September 29, 2016

Re: Proposed Groundwater Water Recovery System and Supporting Groundwater Model for the FPL Turkey Point power plant facility and Cooling Canal System (CCS) located at, near or in the vicinity of 9700 SW 344 Street, Miami-Dade County, Florida (DERM HWR-821, IW-3 & IW-16).

On May 16, 2016, FPL submitted a three-dimensional, variable density dependent transient groundwater flow and transport Model (the Model) and a proposal for a groundwater recovery well system in fulfillment of paragraph 17.b. of the October 7, 2015 Consent Agreement (CA) between Miami-Dade County and FPL. On May 23, 2016, June 10, 2016, and July 14, 2016, FLP submitted supplemental information in support of the May 16, 2016 submittal.

Figure 16. Simulated water levels in the CCS canal and model Layer 1 in monthly calibration model.

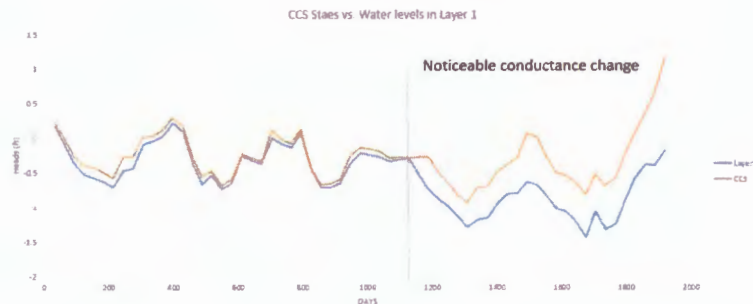
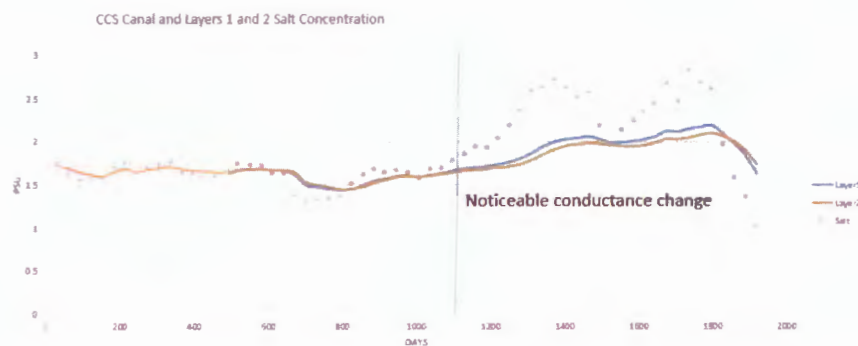
was made towards the end of the calibration period, and it seems to have occurred only at the CCS area. However, the change indicates a very different set of conditions for the remediation simulations as compared to the model calibration efforts. The impact of this change may also significantly affect the simulation results as shown in Figures 16 and 17.

Review of the figures indicates that the simulated heads and salinity start to deviate from the values specified in the CCS after the river conductance values are reduced. This impact is also observed in the model calibration time series (from the Tetra Tech PowerPoint presentation presented as Figure 18).

Figure 18. Salinity calibration results of the monthly model (Tetra Tech, 2016).

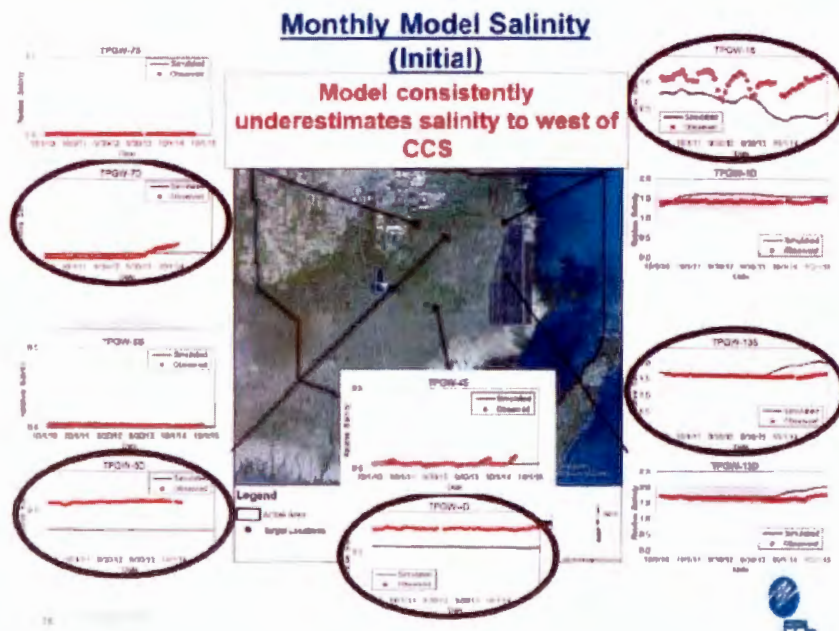
As shown above, simulated salinity values in the calibration target monitor wells, TPGW-13S and TPGW-13D, started moving away from observed values at approximately the end of 2013. Another monitoring well, TPGW-7D, located a significant distance away from the CCS, also showed a similar pattern change. The revised river conductance values for the CCS were used in all of the predictive models. This is a concern. The change of the river conductance beneath the CCS was significant and made at a very late stage of the model calibration period. The reduced river conductance may not be representative of actual field conditions and was not considered during most of the model calibration period. The validity of the prediction scenarios are therefore placed in question because of the significance of the change and the late stage of the change in the area most critical for performance evaluation of the proposed remediation measures.
